NOTICE OF REGULAR MEETING OF THE PLANNING AND ZONING COMMISSION HICKORY CREEK TOWN HALL 1075 RONALD REAGAN AVENUE, HICKORY CREEK, TEXAS 75065 TUESDAY, FEBRUARY 21, 2023, 6:00 PM

RE: The Learning Experience – Site, Landscape, Construction Plans 3rd Review

RE: The Reserve at Hickory Creek – Final Plat, Site and Landscape Plans

This letter is in response to your team's comments, dated February 16, 2023. Comments are listed first followed by Kimley-Horn and Associates, Inc.'s response in bold italics. We hope these responses address your review comments.

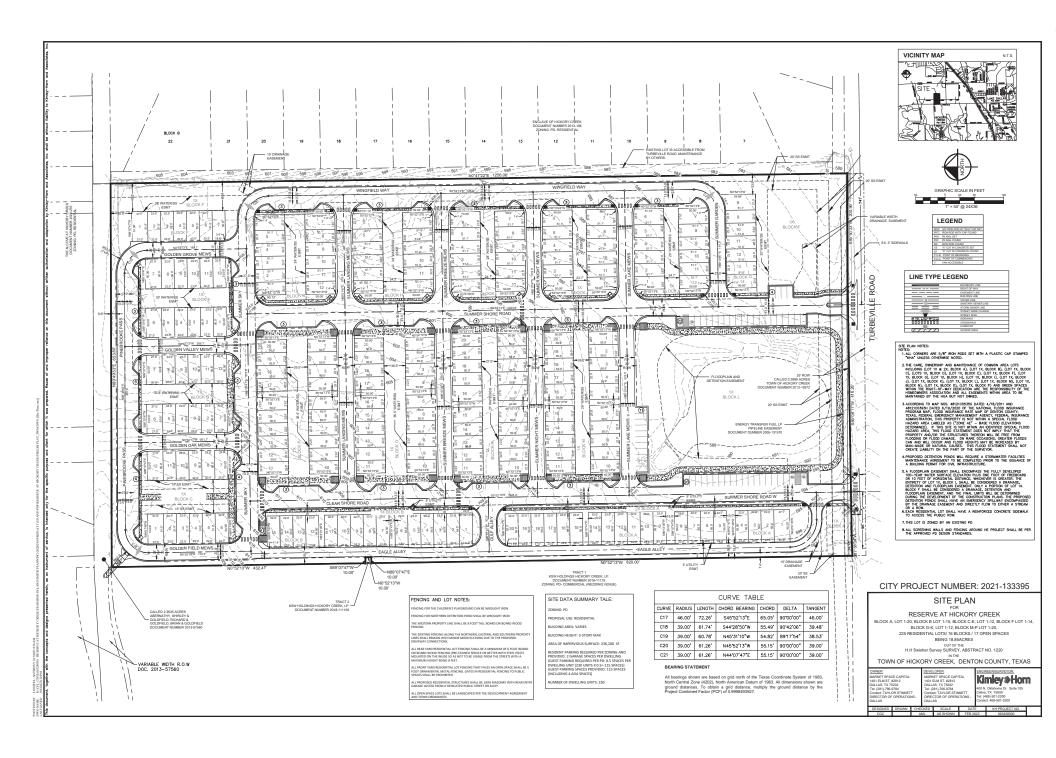
4. The planned detention ponds will require an emergency spillway encompassed by a drainage easement that directs overflow either to the stream or to ROW.

2nd Review: Drainage easement was added to cover the storm drain line and outfall but does not extend to cover the channel to the ROW line. The drainage easement must extend to the ROW line.

Include note about building setback lines not being shown because there is no minimum setback in the Planned Development zoning. Refer to the ordinance number.

2nd Review: Note added. Please add a reference to Resolution No. 2022-0801.

Response: Revised easement line to extend to the ROW at the southeast corner of the project site.

Response: Revised note to include resolution number.
